ZONE CHANGE
 MONCLOVA TOWNSHIP
 LUCAS COUNTY PLANNING COMMISSION
 REF: Z17-C349
 DATE: October 28, 2015
 TIME: 9:00 a.m.

PRELIMINARY PLAT
MONCLOVA TOWNSHIP
LUCAS COUNTY PLANNING COMMISSION
REF: S-20-15
DATE: October 28, 2015
TIME: 9:00 a.m.

PRELIMINARY DRAWING

PRELIMINARY DRAWING
OF
**Crystal Ridge
Plats 2 thru 6**
A PLANNED UNIT DEVELOPMENT
MONCLOVA TOWNSHIP, LUCAS COUNTY, OHIO

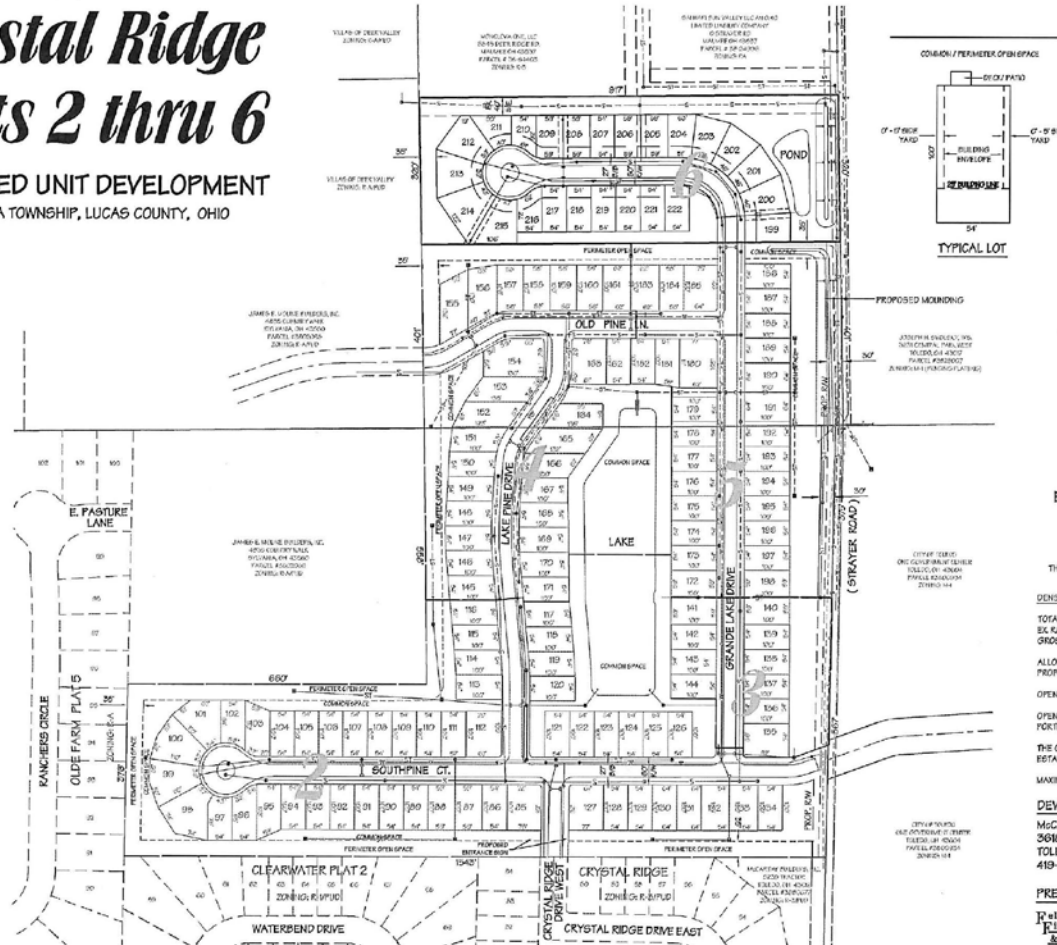
Pursuant to the Monclova Township Zoning Resolution, PUDs require no minimum lot size, lot-width, building or structure setbacks. However, staff noticed that Lot 210 appeared to have a significantly reduced building envelope due to its location on the cul-de-sac. The applicants engineer has indicated that a minor change in the plan will off-set the cul-de-sac to the south therefore creating an additional building envelope size for lot 210.

The Lucas County Subdivision Rules and Regulations, *Sec. 507.f*, requires that any subdivisions with adjacent undeveloped land create stub streets to connect future development. The site has undeveloped land to the north. A waiver of the stub street to the north is not supported by staff as the potential exists for the development of this land into the future. The roadway extension to the north would require the reconfiguration of the proposed subdivision lots.

When a residential area of a Planned Unit Development abuts an Industrially Zoned District, an open space perimeter area shall be provided that has a minimum depth of seventy-five (75) feet. This open space shall be void of buildings, structures, parking areas, or other above-ground improvements except fencing shall be maintained along all perimeter property lines of the Planned Unit Development. The previously approved plat and planned unit development allowed for the construction of mounding along the entire eastern property line. The applicant was indicated that the mounding appeared to only extend midway down Plat 5, the applicant stated that this was in error and the mounding was intended to extend the entire length of the western property line.

10. Road name is not identified on the drawing. Road name subject to review and approval of the fire department to avoid similar sounding road names in the area.

15. There should be more information identifying plat six in particular i.e. acreage, number of lots etc.
16. The perimeter open space for plat six should be labeled.

29. The preliminary plat drawing for Eclat Commerce & Business Center includes a future extension and widening of Strayer Rd. beginning at the intersection of Jerome Rd. and Technology Drive and extending westerly and then curving to the north to connect at Maumee-Western Rd. (US 20A). An additional fifty (50) foot right of way and twenty-five (25) foot highway & utility easement shall be dedicated in accordance with the proposed future street alignment at the northeast corner of Plat 6 to accommodate this future roadway extension and widening.

30. A street name shall be provided for the cul-de-sac in Plat 6.
31. The developer shall be responsible for the actual plan review and construction inspection time performed by the County Engineer's Office associated with the pavement and drainage

35. Per Lucas County Subdivision Rules and Regulations **Sec. 507.f**, a stub street shall be required for the undeveloped land to the north unless a wetland delineation identifies the presence of wetlands that would prohibit development to the north.

Subdivisions are required to provide stub connections along any perimeter where undeveloped land is present. An undeveloped, fifteen (15) acre parcel exists to the north of the site and is conducive to future development. Staff recommends that the Lucas County Planning Commission **DENY** of a waiver of the stub street requirement.
